APPLICATION NO.	FILING DATE	FIRST NAMED INVENTOR	ATTORNEY DOCKET NO.	CONFIRMATION NO.
10/596,271	01/22/2007	Axel Feger	ARY0003	4748
832 7590 12/24/2008 BAKER & DANIELS LLP 111 E. WAYNE STREET SUITE 800 FORT WAYNE, IN 46802				
EXAMINER				
KEE, FANNIE C				
ART UNIT		PAPER NUMBER		
3679				
MAIL DATE		DELIVERY MODE		
12/24/2008		PAPER

Office Action Summary

10/596,271

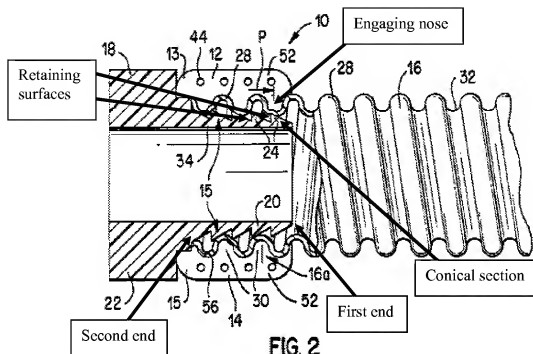
With regard to claim 7, and as seen in Figure 2 below, Merrett discloses a connector for connecting to the end of a corrugated conduit, said corrugated conduit including a plurality of elevated corrugations, said connector comprising:

an elongated connector portion (15) adapted for insertion into a said end of a said corrugated conduit, said connector having a longitudinal axis, said connector portion having first and second ends, said connector portion having a conical section located proximate said first end, said conical section including a ramp surface (24) which slopes radially outwardly in the direction of said second end;

a clamp (12, 14) spaced radially from said first end, said clamp including an engaging nose which is adapted to move into a clamping position wherein said nose fits between two of said elevated corrugations to thereby prevent said conduit from being separated from said conduit.

With regard to claim 8, and as seen in Figure 2 above, Merrett discloses said connector portion further including a radially outwardly extending retaining surface adjacent said ramp surface, said retaining surface facing said second end and being directed at a greater angle relative to said longitudinal axis of said connector portion than said ramp surface.

With regard to claim 9, and as seen in Figure 2 above, Merrett discloses two ramp surfaces (24, 24) and two retaining surfaces.

With regard to claim 11, and as seen in Figure 2 above, Merrett discloses said clamp comprising two clamping brackets (12, 14) disposed parallel to said longitudinal axis on

respective opposite sides of said connector portion, one of said brackets including said engaging nose.
